Re-Bid Pre-Bid Addendum #1

Sheet Title
FIRE ALARM PLANS

Sheet No.
E-5
CONSTRUCTION DOCUMENTS

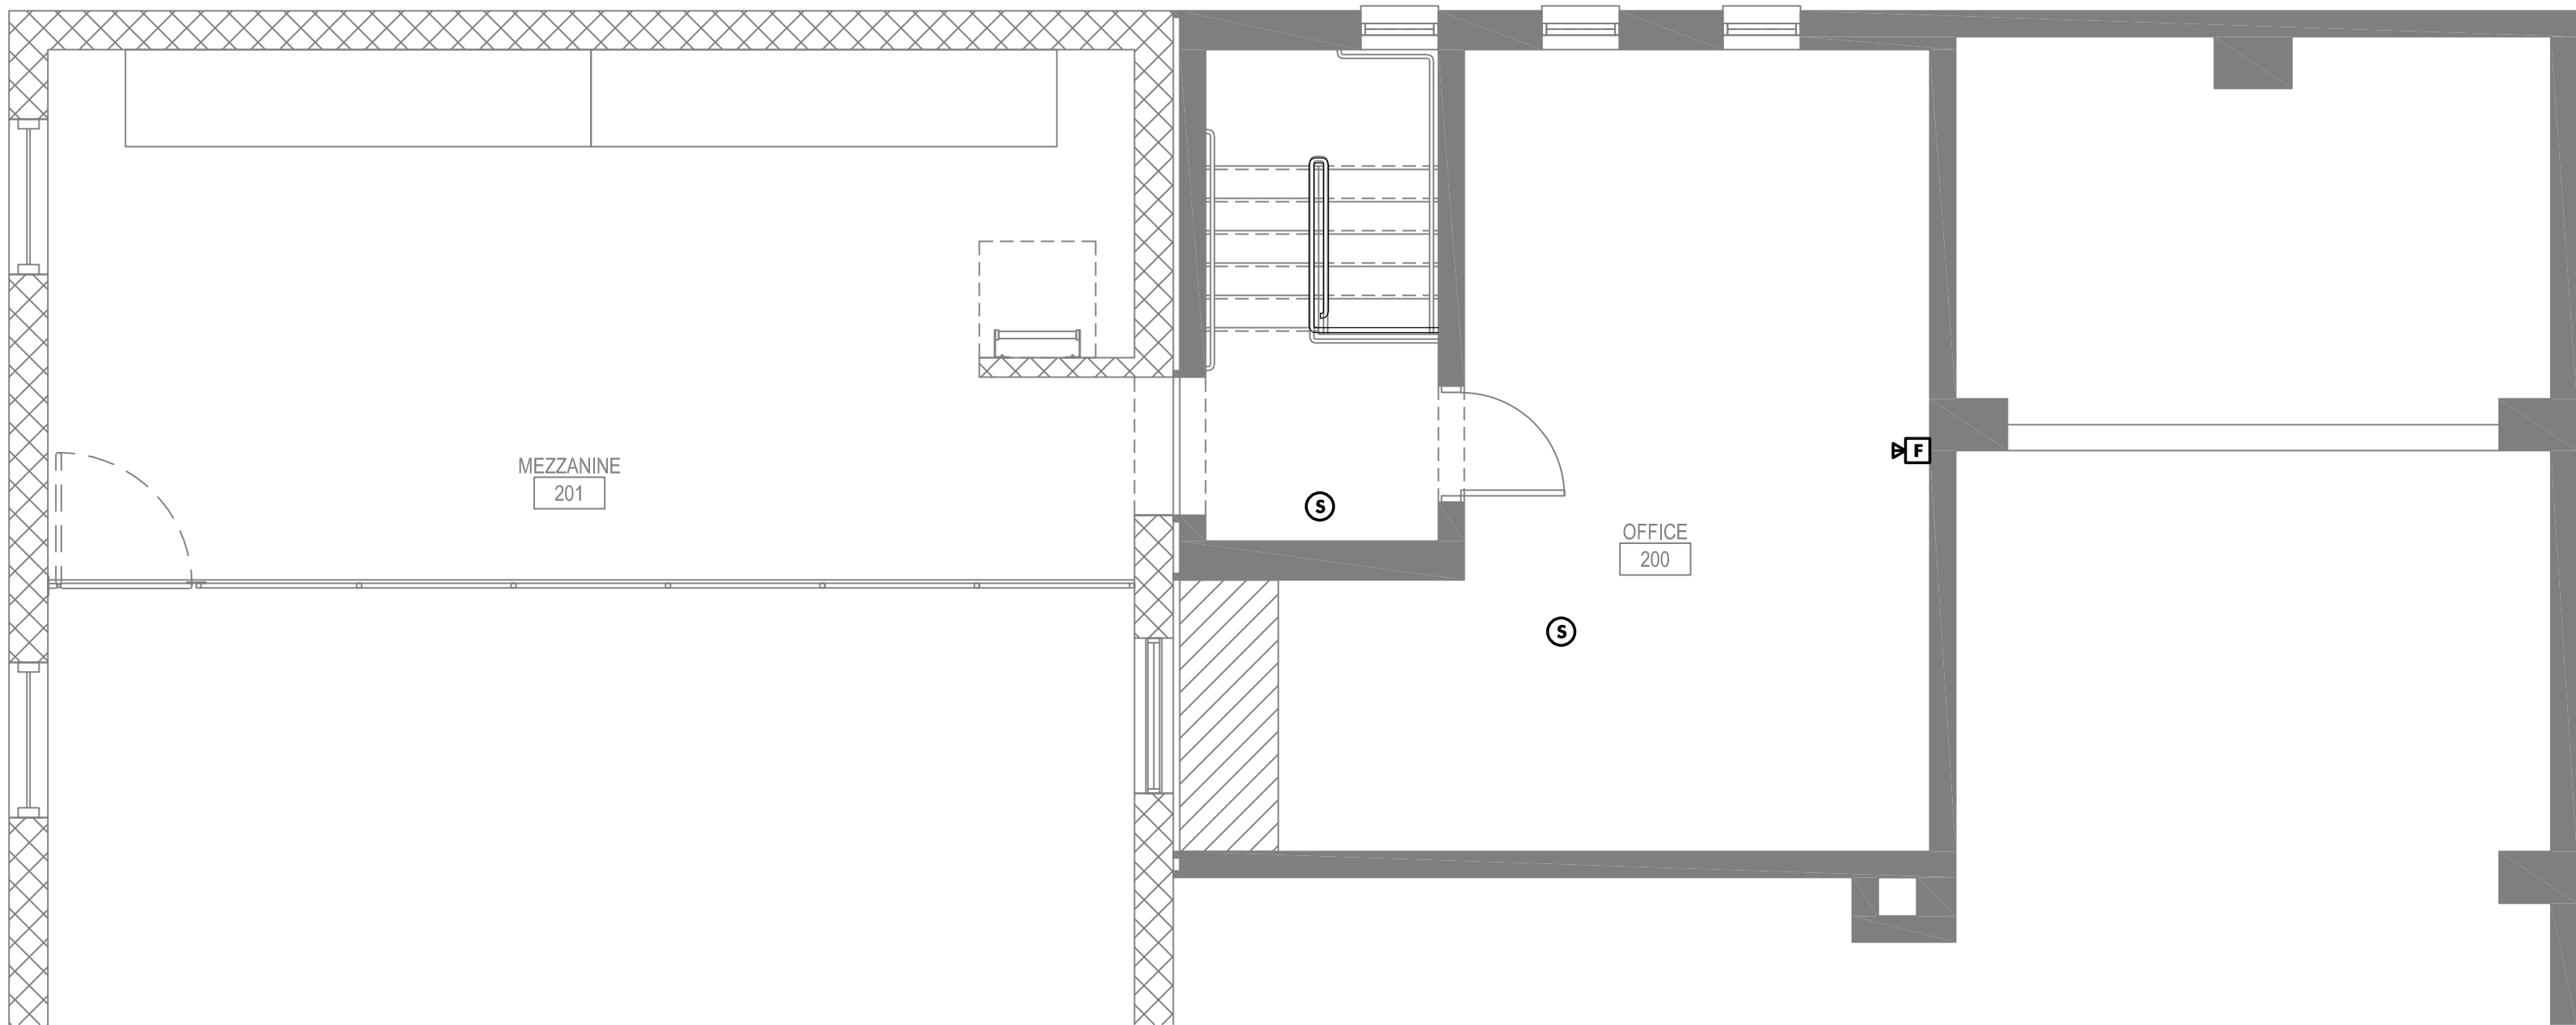
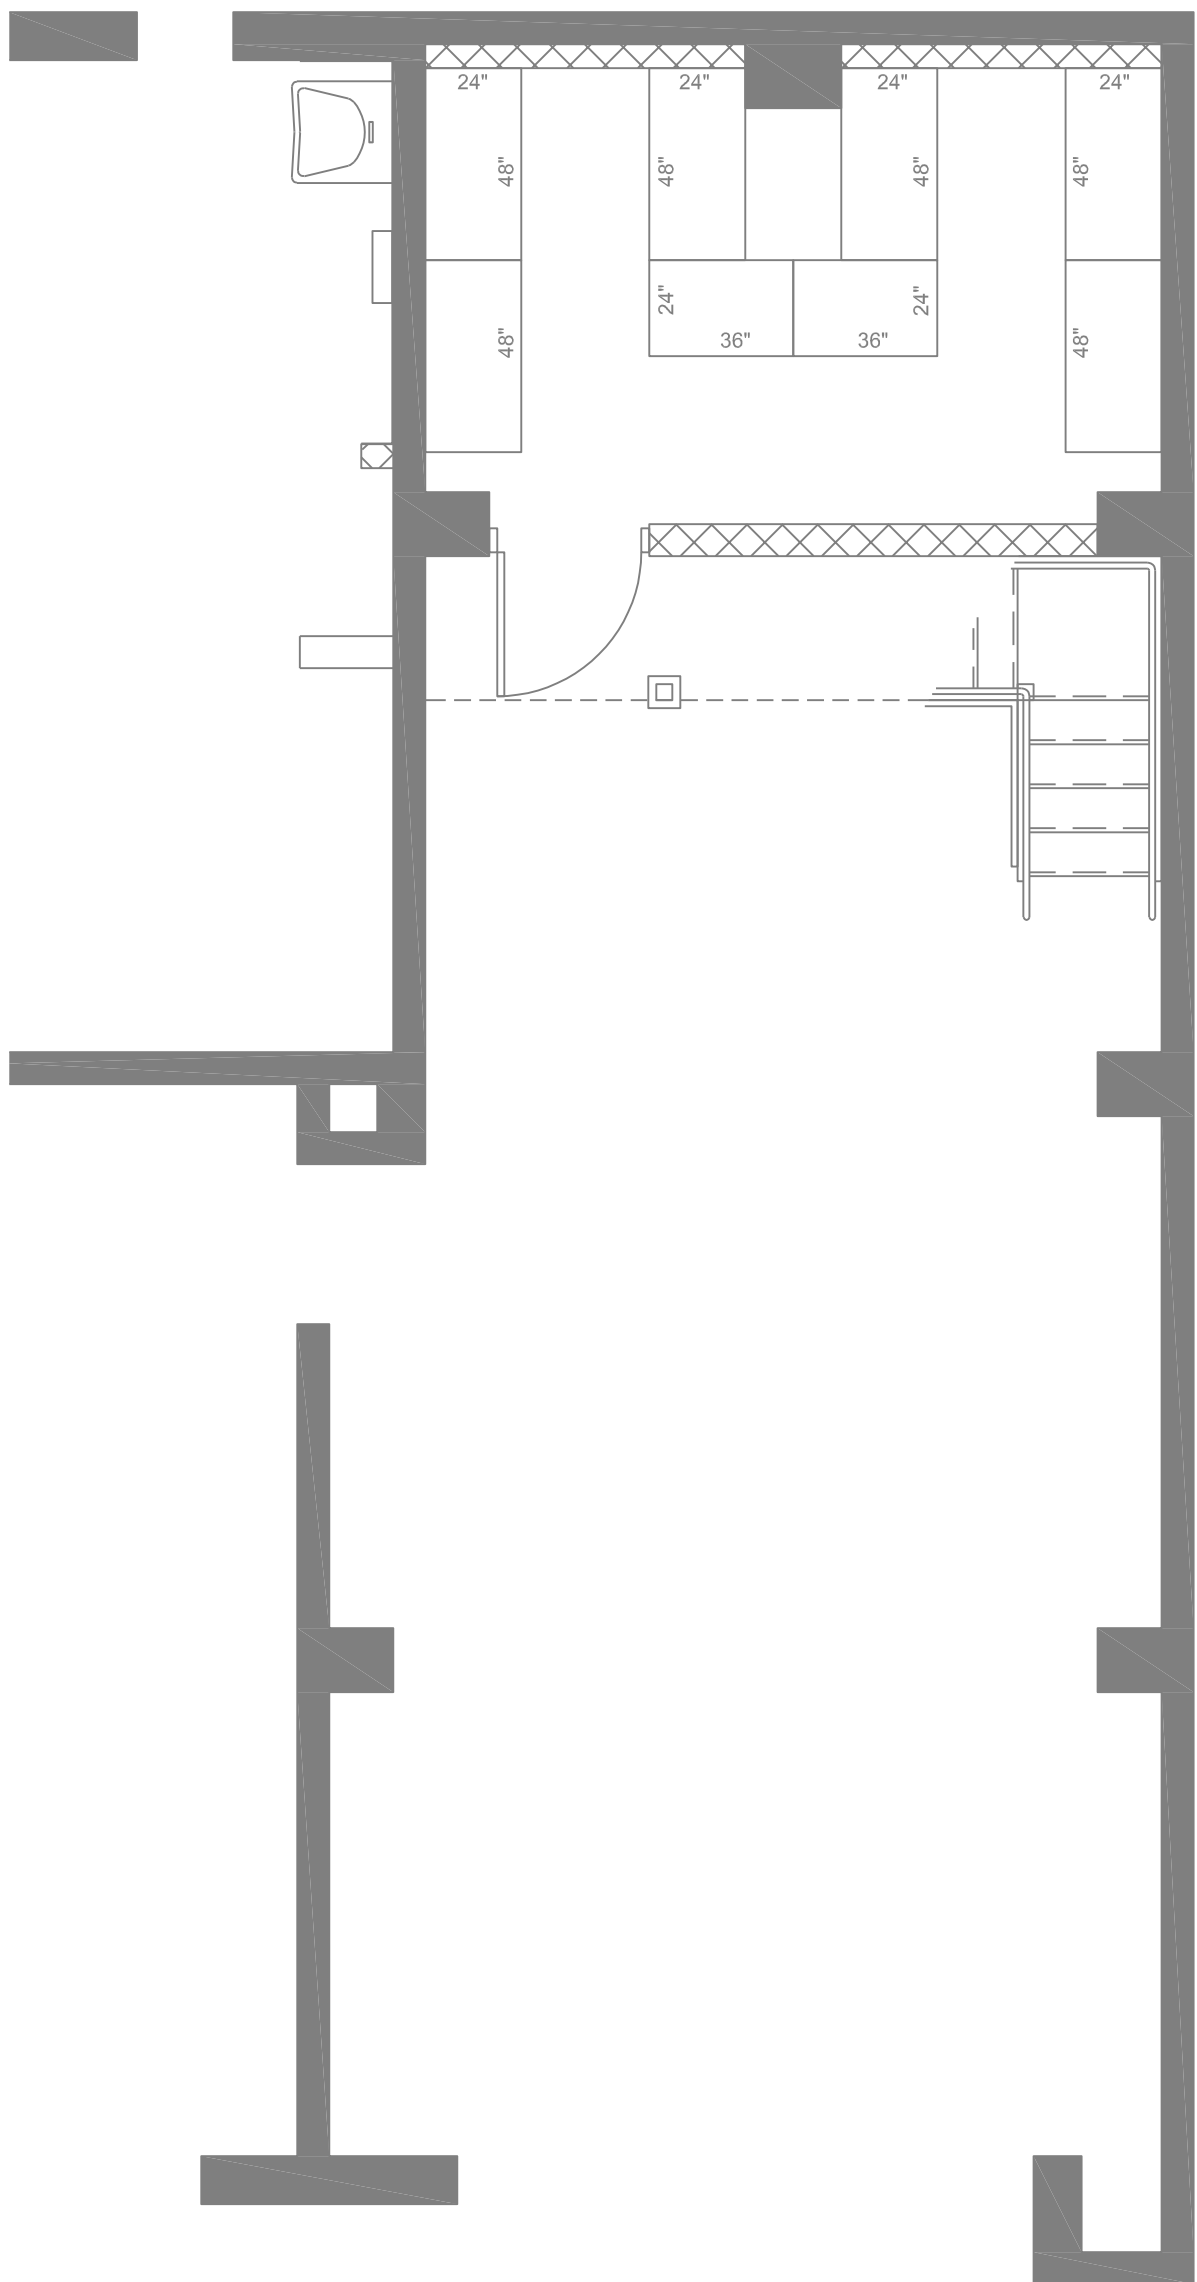
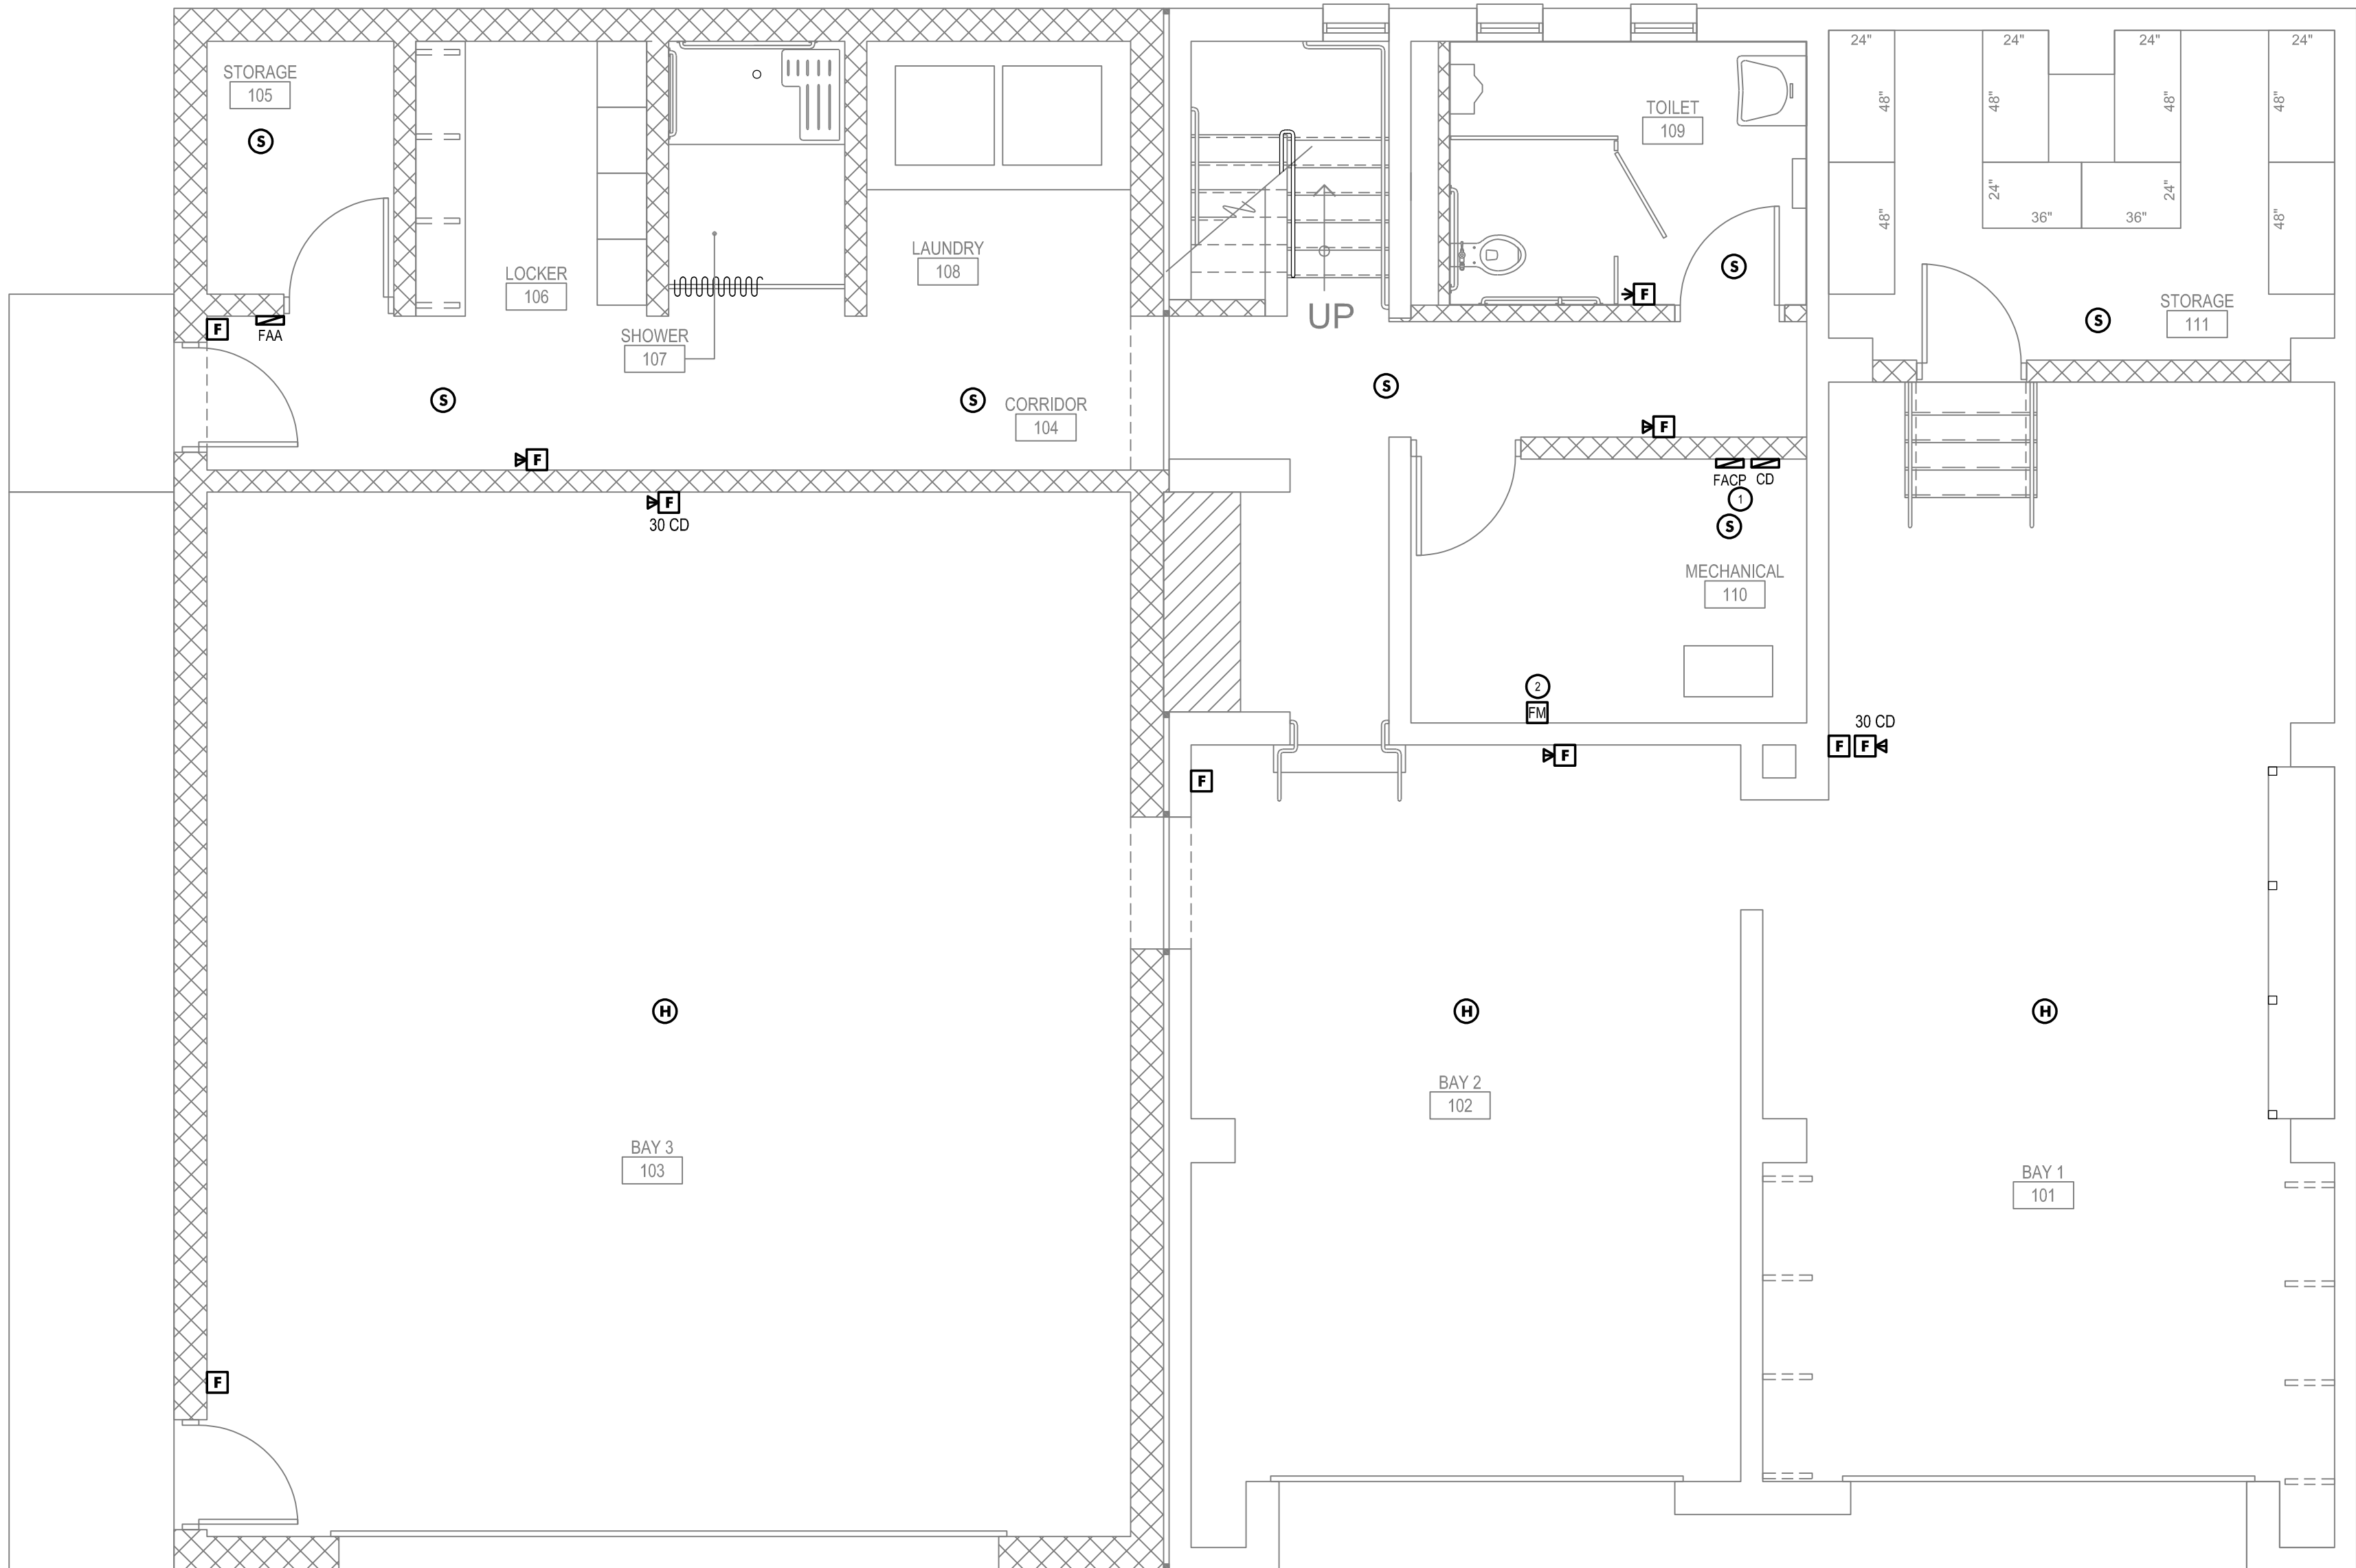
2. **Add** Drawing E-5 Fire Alarm Plans.
